**SUBJECT:** Savannah River Site's Responses to the Regulatory Comments on the 2016 Annual Comprehensive TNX Area Groundwater Monitoring and Remedial Action Effectiveness Interim Report (U) (SRNS-RP-2017-00302, Revision 0, June 2017) CERCLIS Numbers: 21, 29

**SRS Responses to SCDHEC Comments on the  
2016 Annual Comprehensive TNX Area Groundwater Monitoring and Remedial Action  
Effectiveness Interim Report (U), CERCLIS Number: 21, 29, SRNS-RP-2017-00302,  
Revision 0, Dated June 2017, Savannah River Site, Aiken, South Carolina**

**SRS Responses to USEPA Comments on the  
2016 Annual Comprehensive TNX Area Groundwater Monitoring and Remedial Action  
Effectiveness Interim Report (U), CERCLIS Number: 21, 29, SRNS-RP-2017-00302,  
Revision 0, Dated June 2017, Savannah River Site, Aiken, South Carolina**

**Attachment 2. 1,4-Dioxane Time Series Plots**

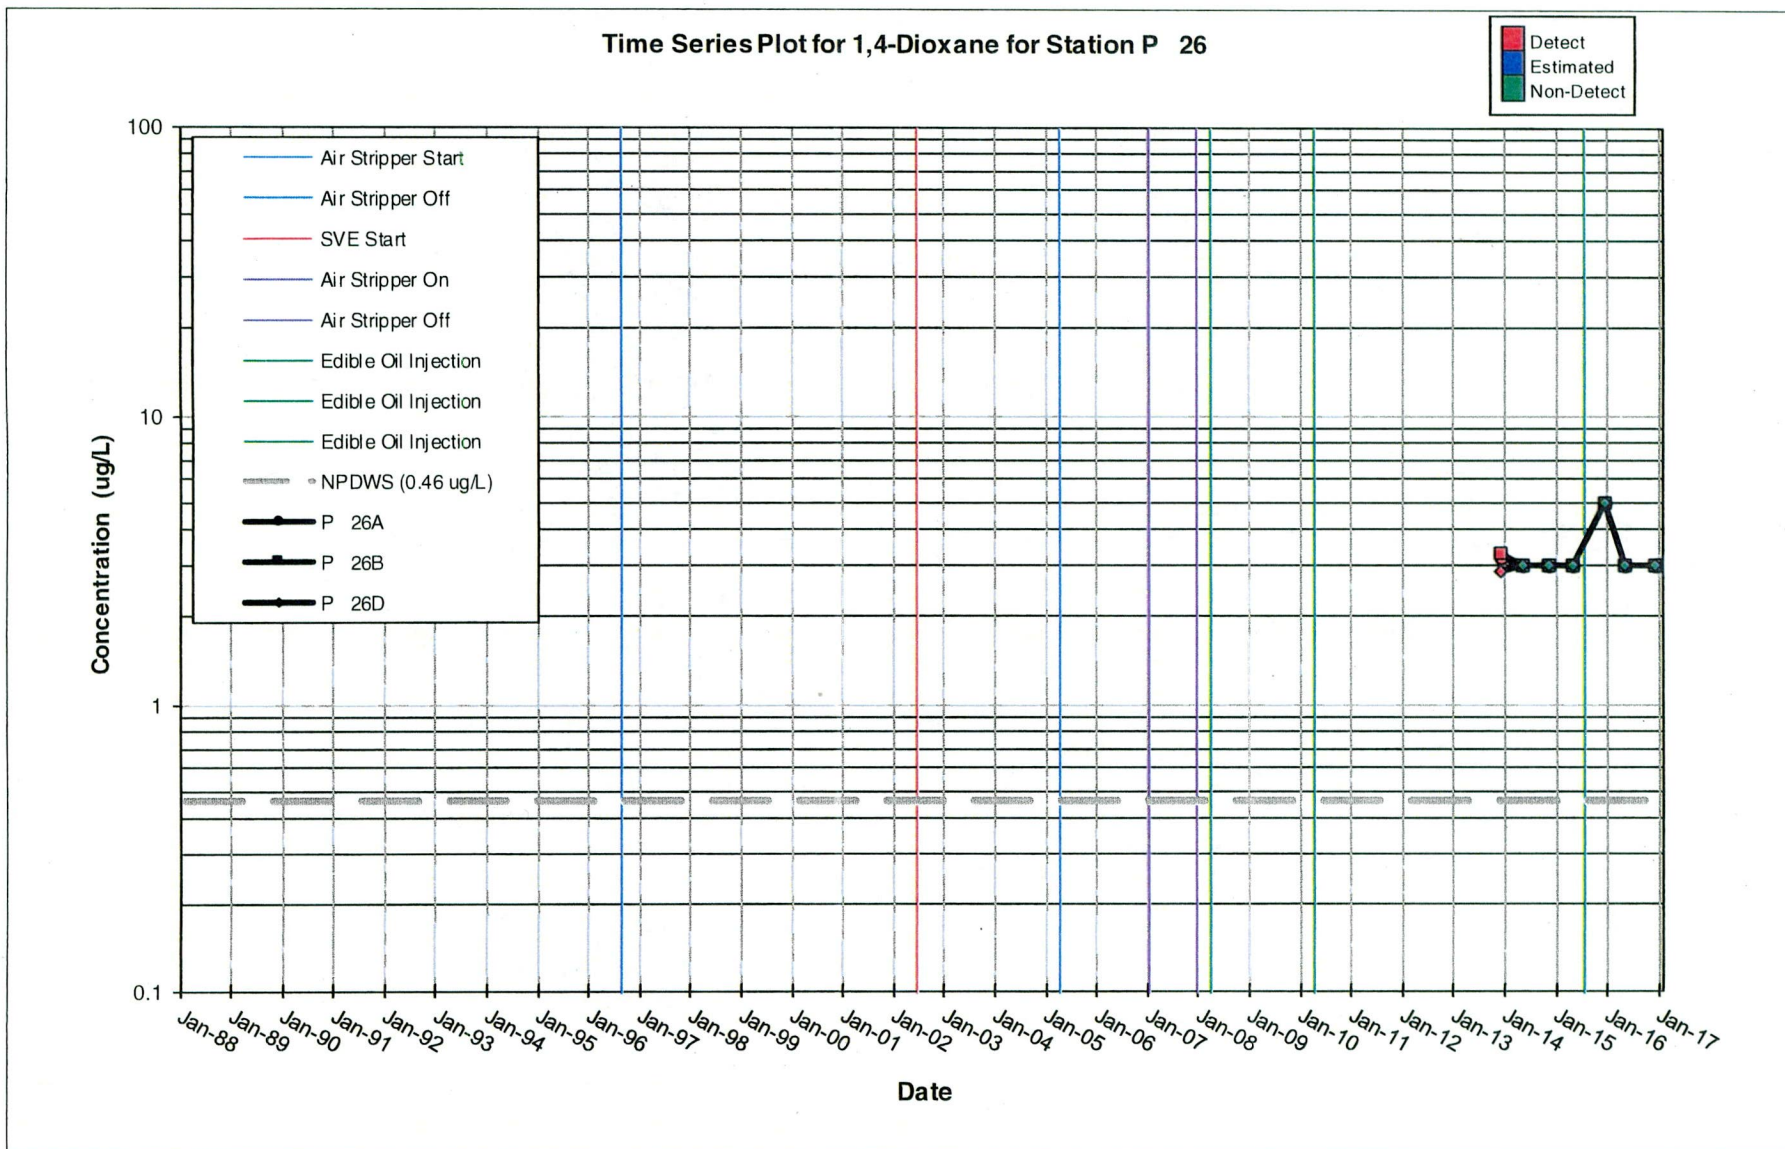
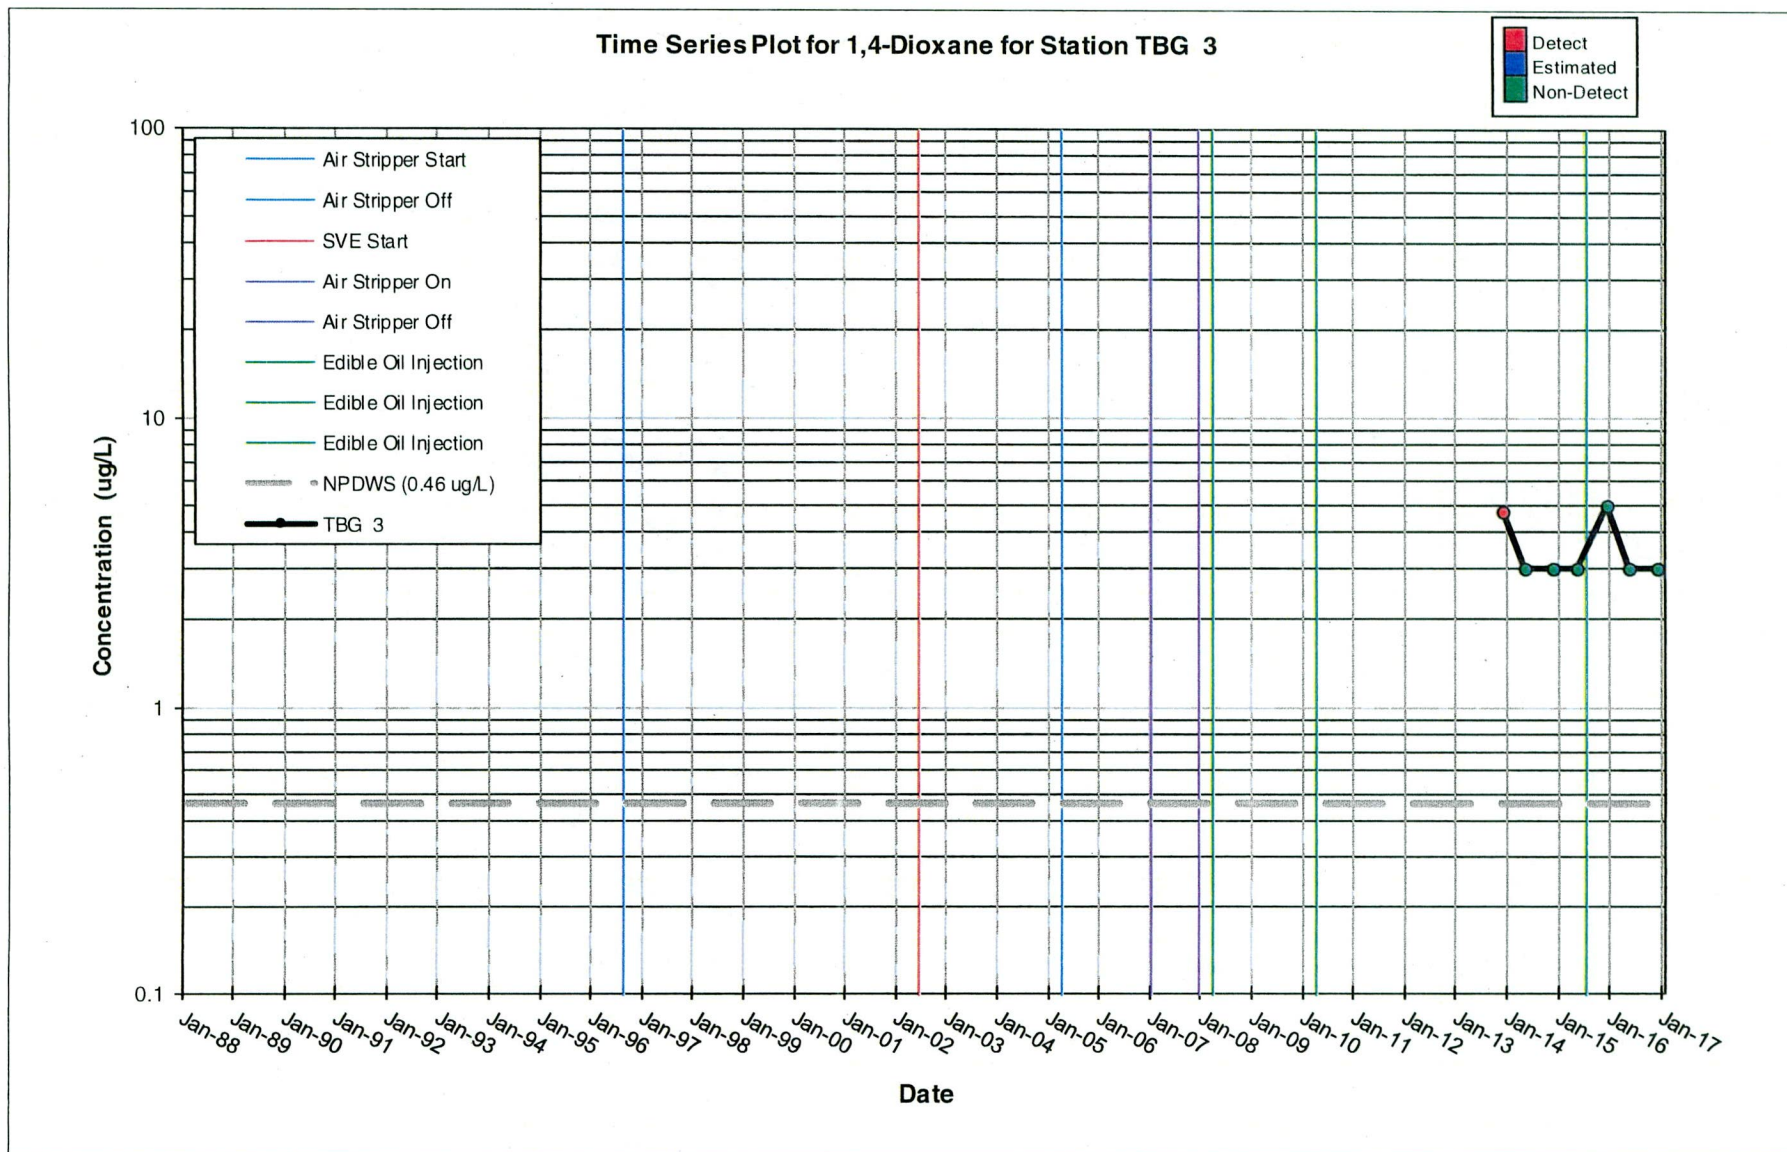
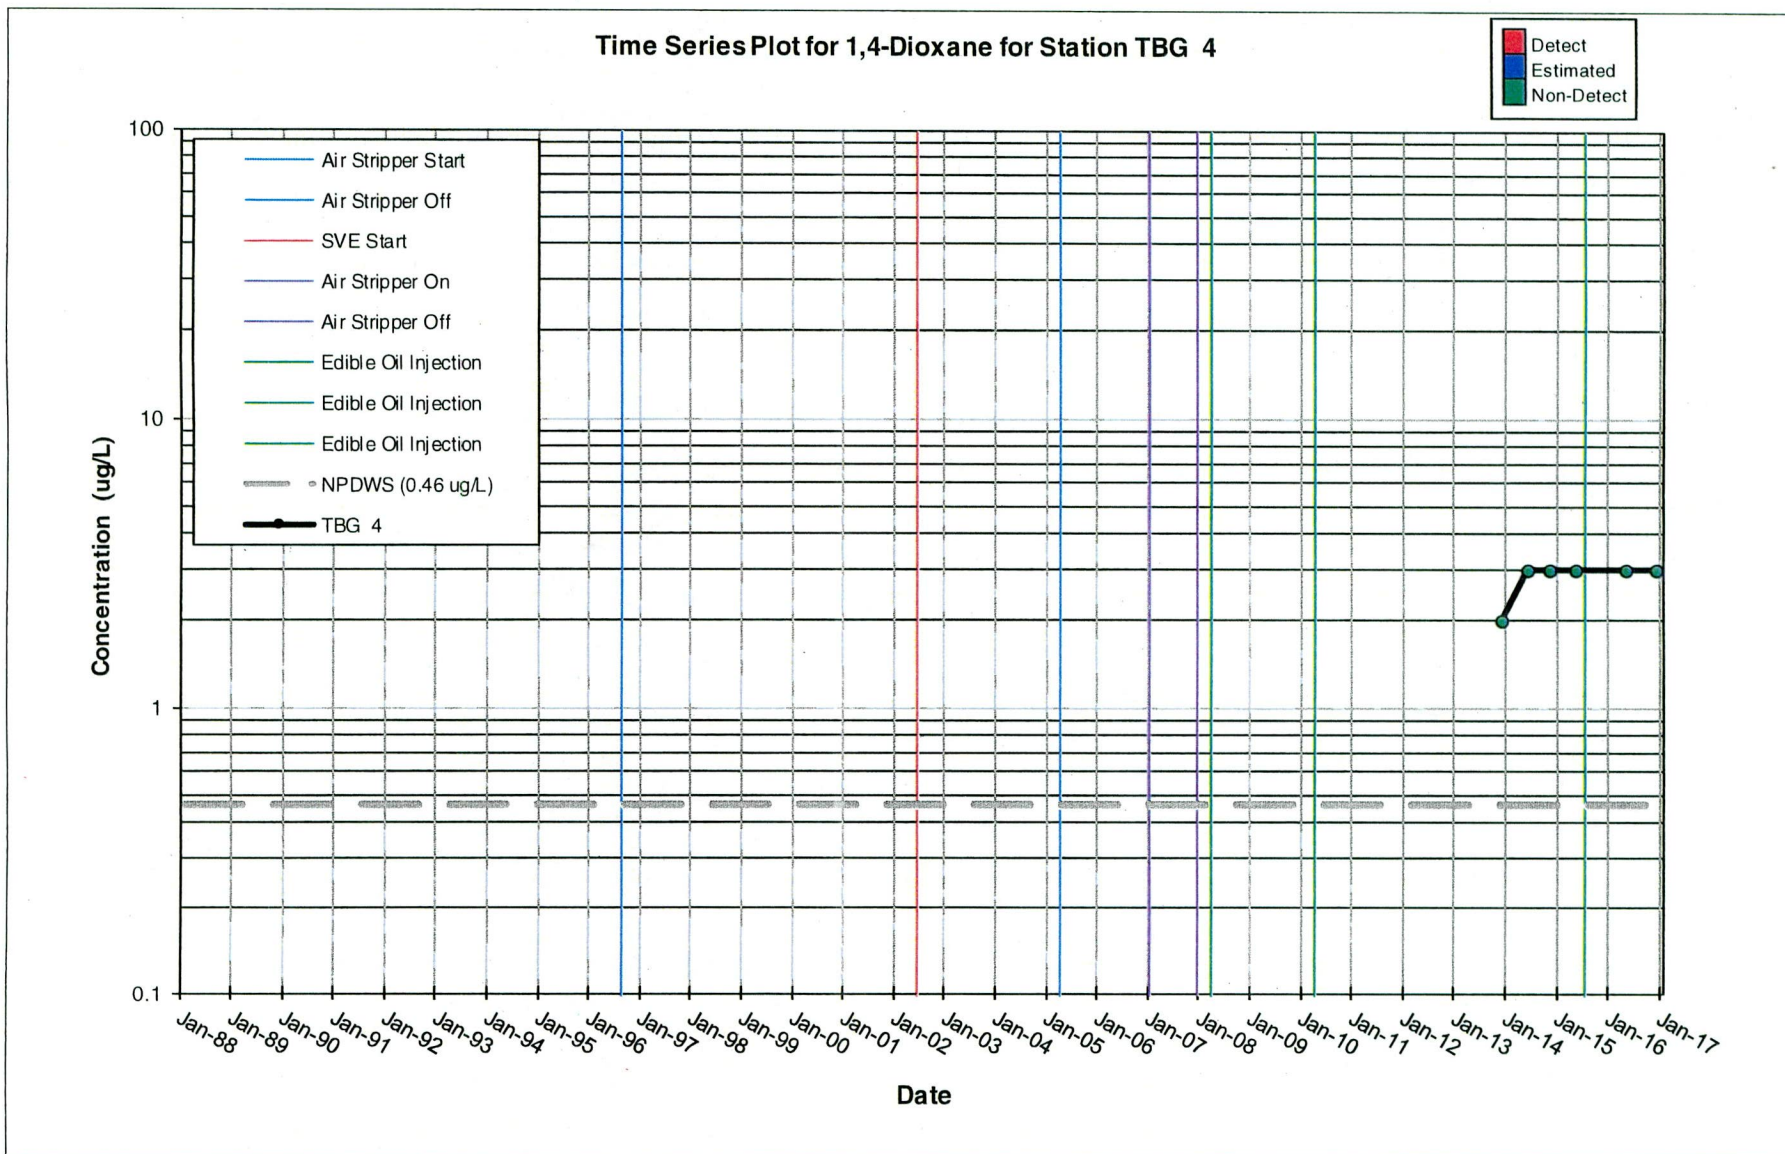
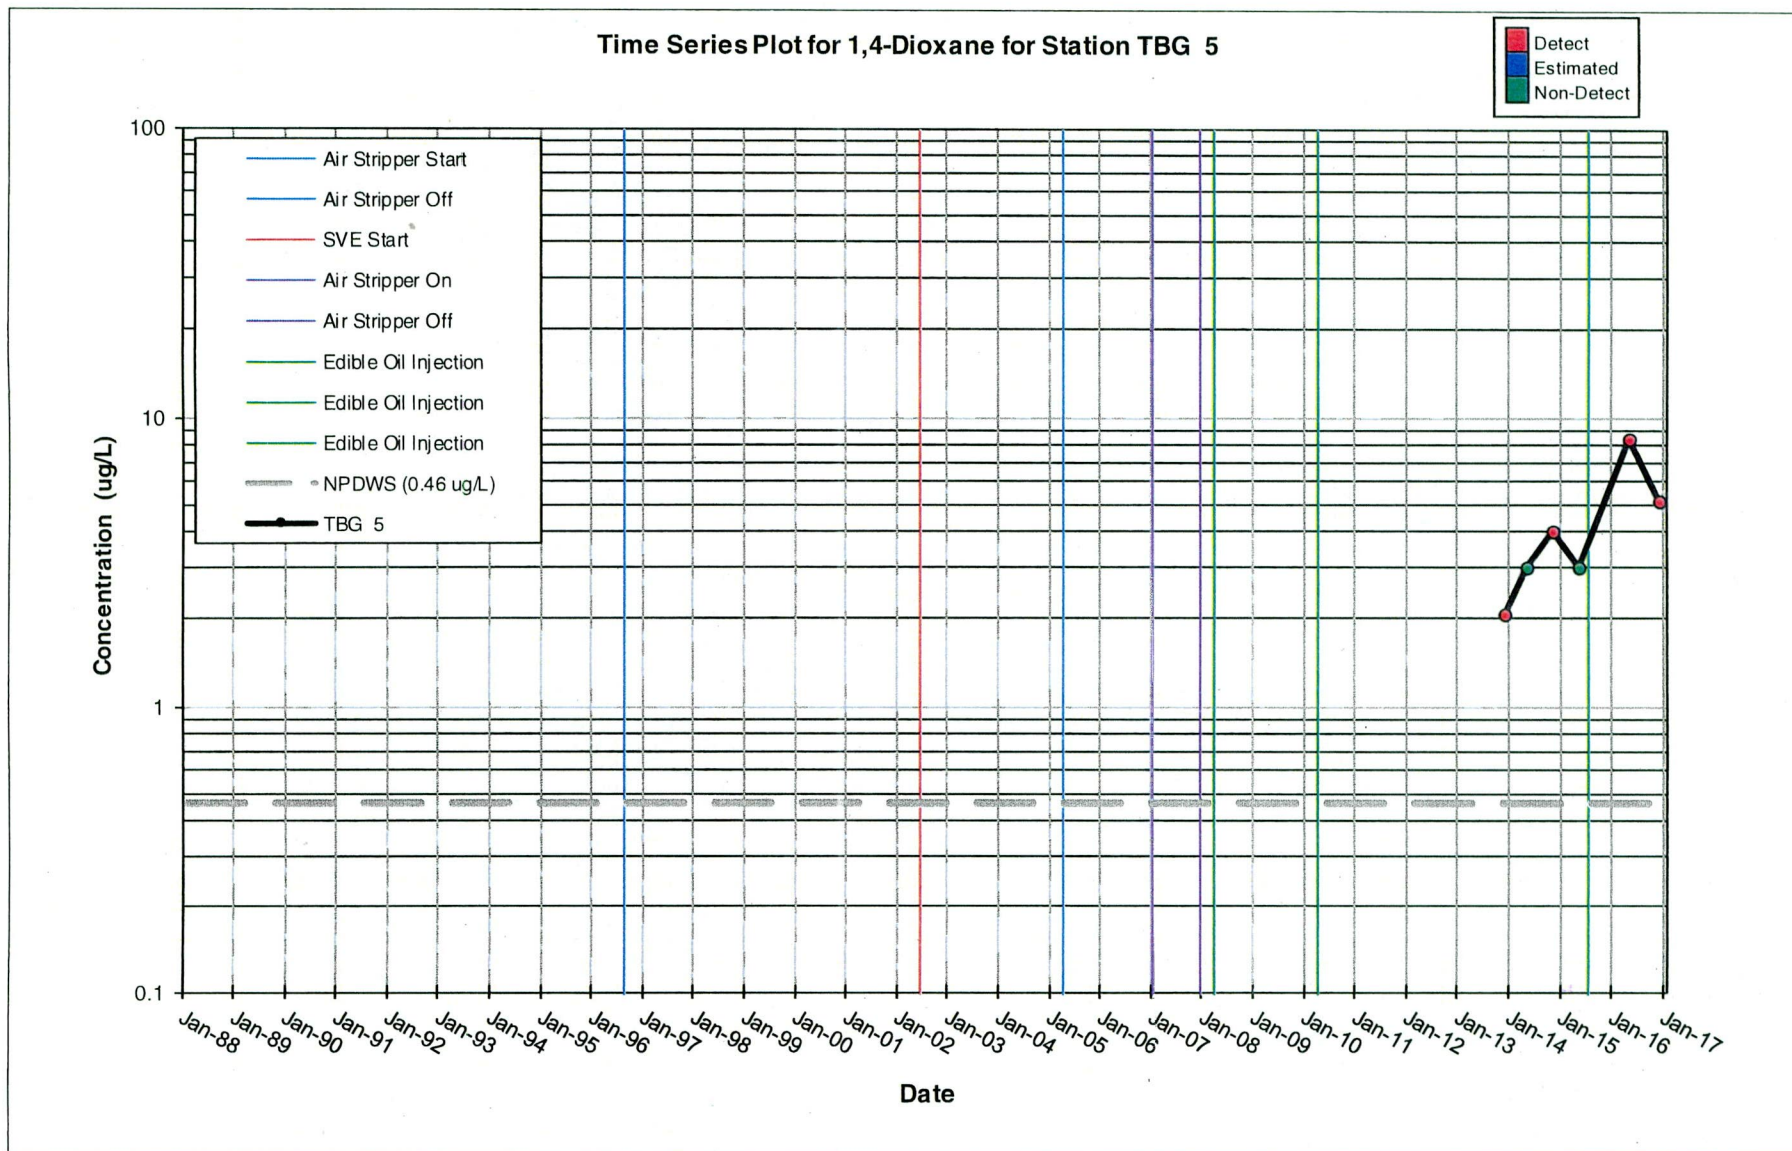
3. **Section 6.7, 1,4-Dioxane, Page 39-40 of 52:** Section 6.7 states, "1,4-Dioxane was initially sampled at all TNX Area OU monitoring wells during the fourth quarter 2013 sampling. Thirty of the 38 monitoring wells had a detection of 1,4-dioxane. The detections were scattered across the TNX Area OU including the background and monitoring wells upgradient of the source areas. It is not apparent why 1,4-dioxane concentrations were detected in almost every monitoring well. Since 2014, 1,4-dioxane concentrations have been less than the detection limit at all wells except TBG 5." However, the data from the fourth quarter 2013 and subsequent sampling events is not included in the report as a supporting line of evidence. Please revise the 2016 Annual Report to include historical groundwater data (including the laboratory detection limits), for 1,4-dioxane along with the additional constituents and parameters sampled for in subsequent sampling events.

The CD submitted with the 2016 Annual Report includes matrix tables from Appendix B. Time series graphs will be added to Appendix E of the 2017 Annual Report to display the historical 1,4-dioxane results for the monitoring well network (Attachment 2). No changes are proposed for the 2016 Annual Report.
